PROJECT DESCRIPTION
 NEW MULTI-FAMILY RESIDENTIAL STRUCTURE WITH CORNER COMMERCIAL SPACE.

DRAWING ACCOMPANYING REQUEST FOR SPECIAL USE 9-14-2015

MIXED USE RESIDENTIAL DEVELOPMENT

1300-1306 McDonough Streets
 [corner of McDonough and 13th]
 MANCHESTER, RICHMOND, VA 23224

FLOOR PLANS

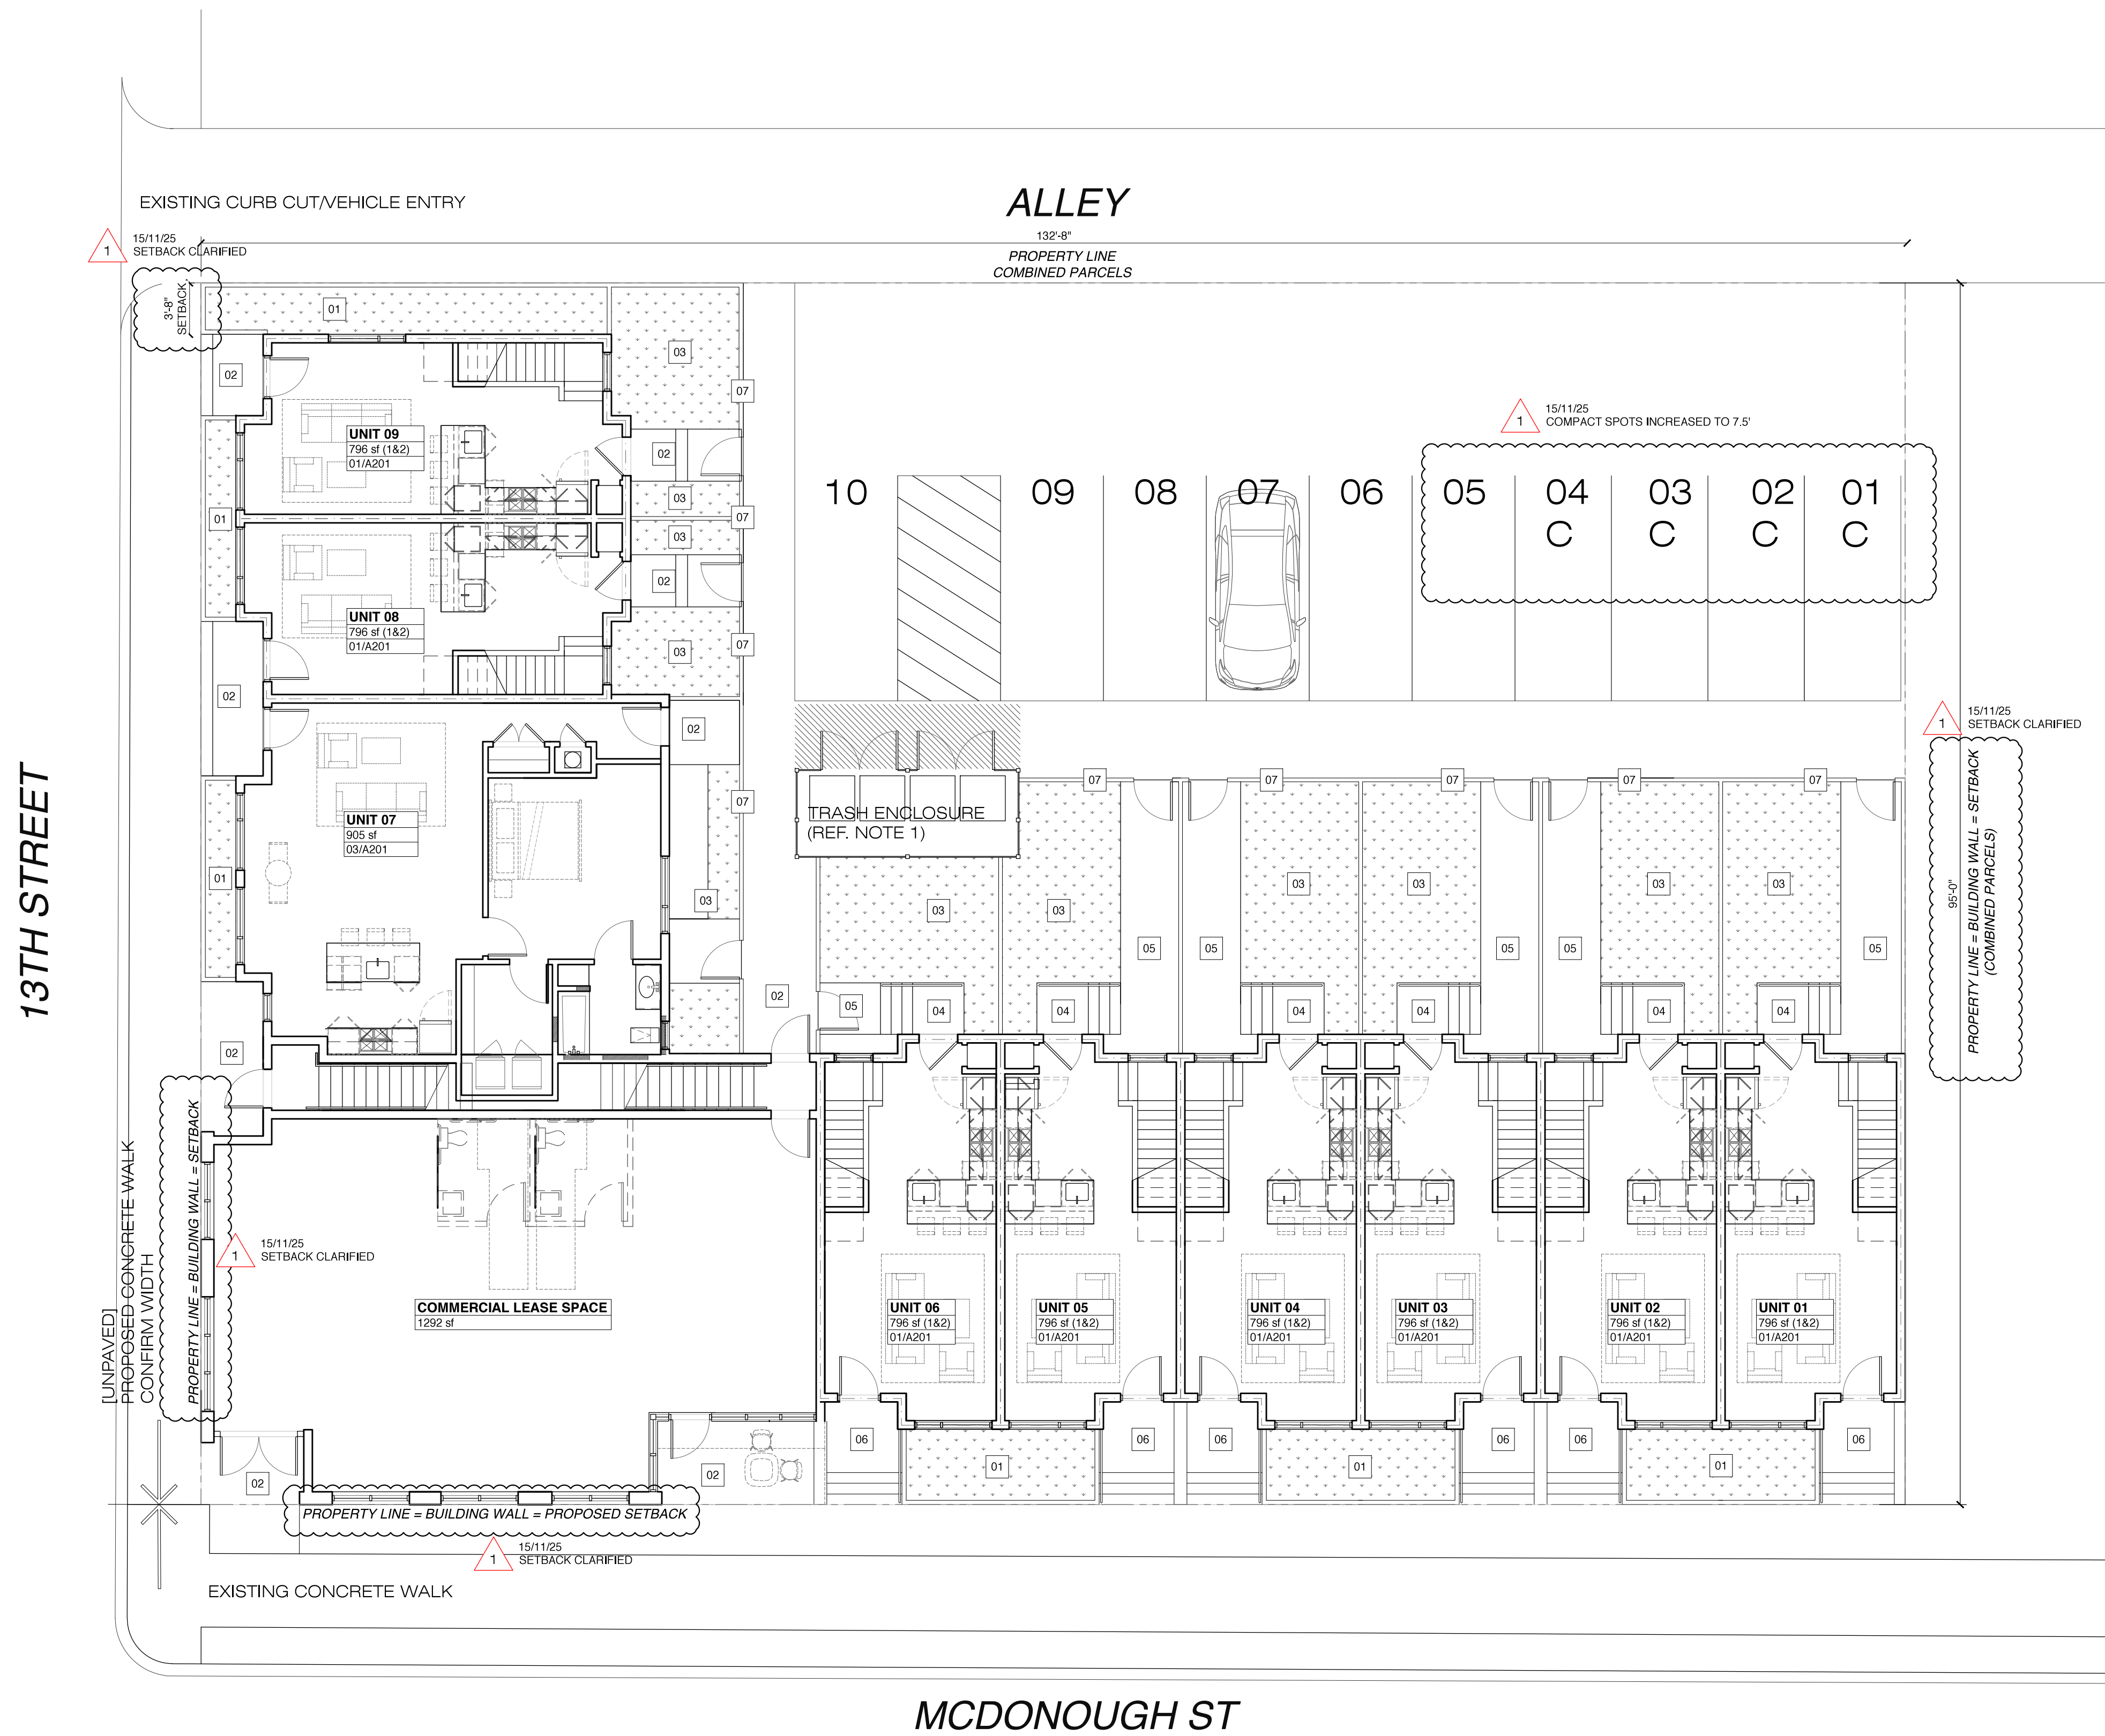
15/11/25
 UNIT SCHEDULE REVISED TO INDICATE SQFT BY LEVEL

15/11/25
 NOTE 7 REVISED TO INDICATE PRIVACY FENCE

ELEVATIONS

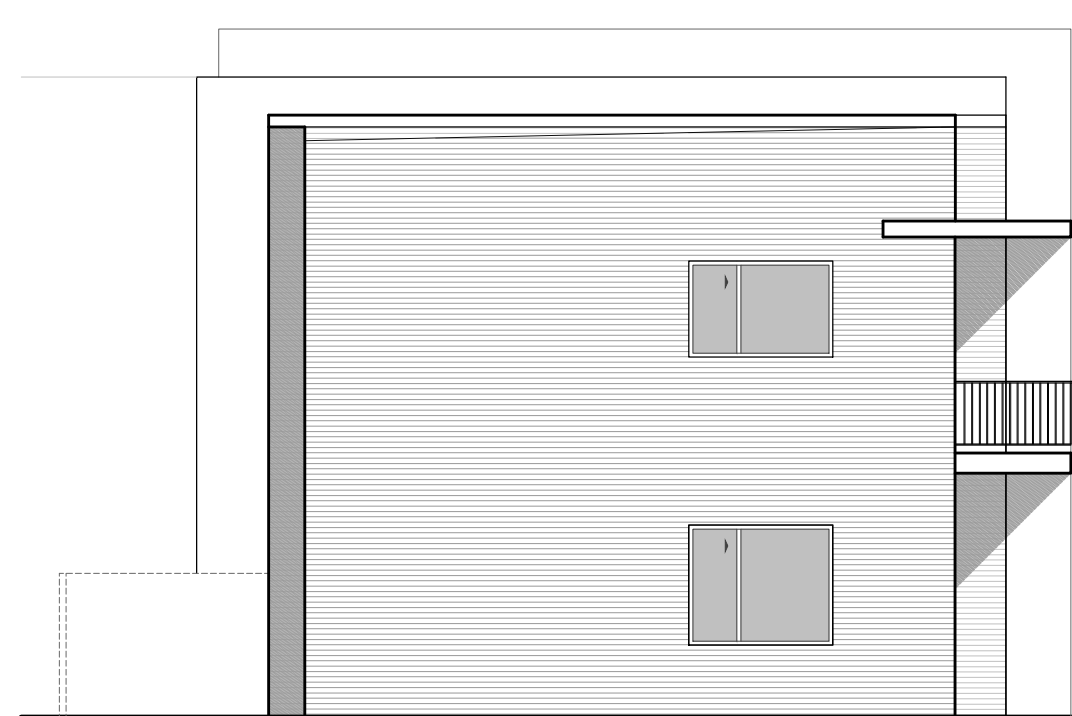
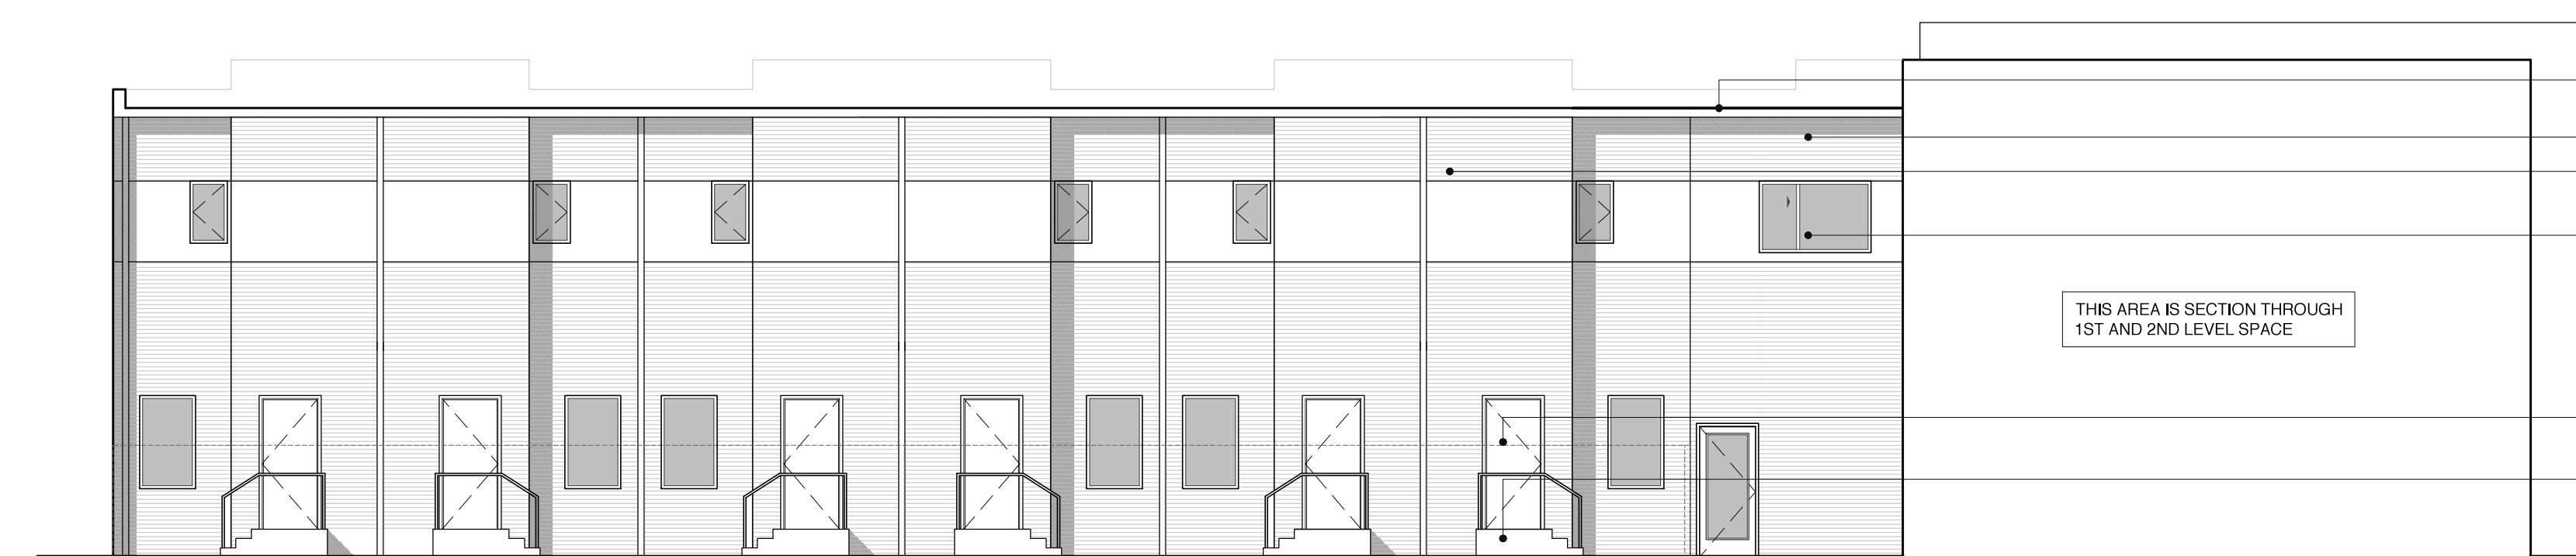
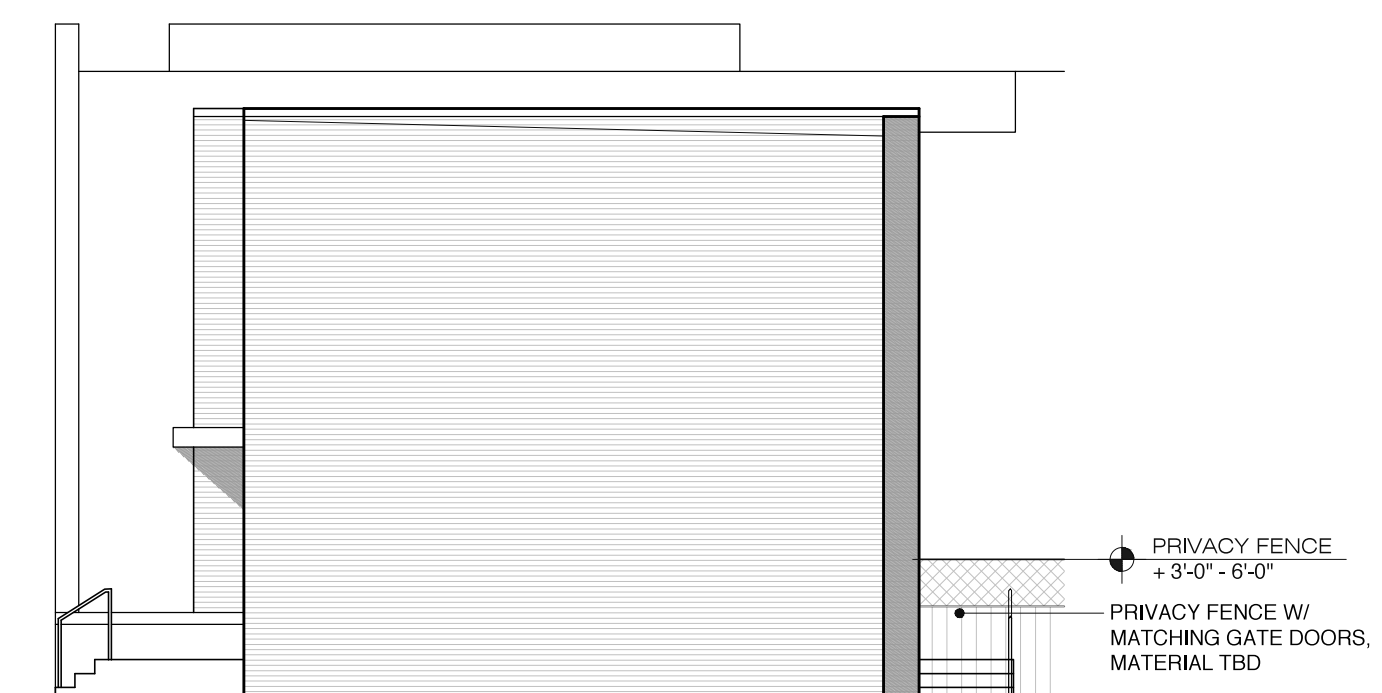
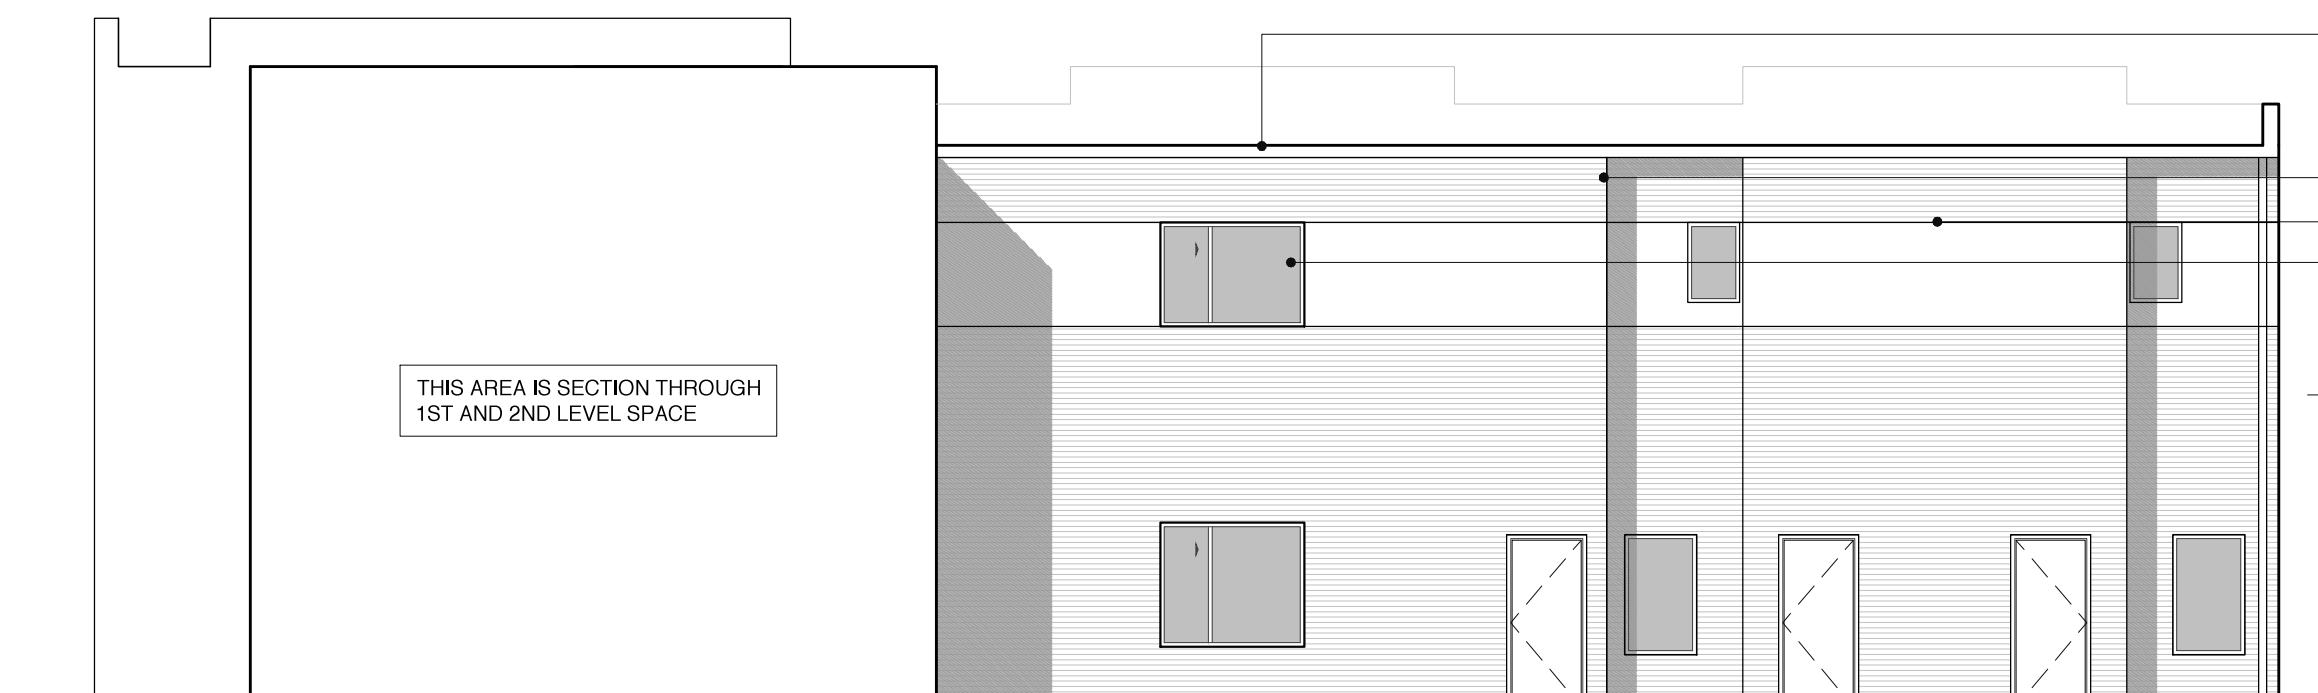
15/11/25
PAINTED METAL RAIL CLARIFIED

1 15/11/25
ELEVATION RAISED 0'-8"

1 15/11/25
PAINTED METAL RAIL CLARIFIED

2 16/01/22
BALCONY ROOF REVISED TO REFLECT SETBACK

16/01/22
BALCONY ROOF REVISED TO REFLECT SETBACK

1 15/11/25
PAINTED METAL RAIL CLARIFIED

2 16/01/22
BALCONY ROOF REVISED TO REFLECT SETBACK

01 CONCEPT FRONT PERSPECTIVE_13TH AND MCDONOUGH
 A302
 NOT TO SCALE

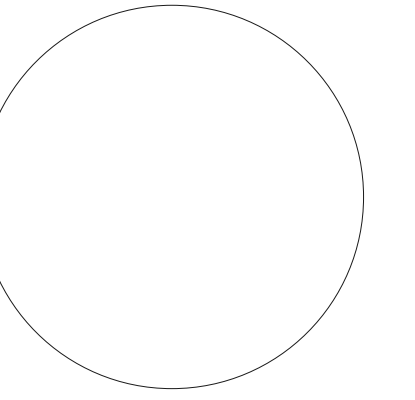
PAINTED METAL BALCONY RAIL
 15/11/25
 1 BALCONY RAIL CLARIFIED
